GUAM POWER AUTHORITY

AMENDMENT NO.: V
TO
INVITATION FOR MULTI-STEP BID NO.: GPA-042-22
FOR
FADIAN PUBLIC PARKING LOT SOLAR CANOPY

Prospective Bidders are hereby notified of the following inclusions and response to inquiries received from Bidder No. 8 dated September 16, 2022 and September 20, 2022, Bidder No. 6 dated September 21, 2022, October 04, 2022:

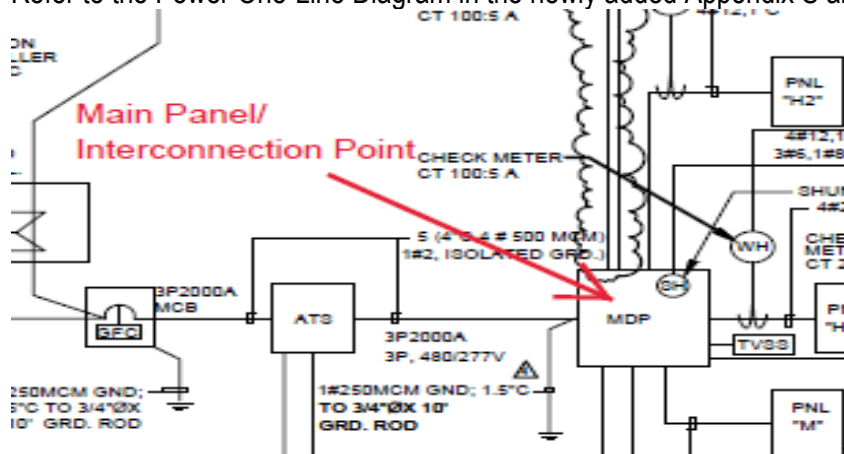
1. QUESTION:

Can GPA provide a single-line diagram on the planned interconnection point?

RESPONSE:

Refer to the Power One-Line Diagram in the newly added Appendix S and the diagram below:
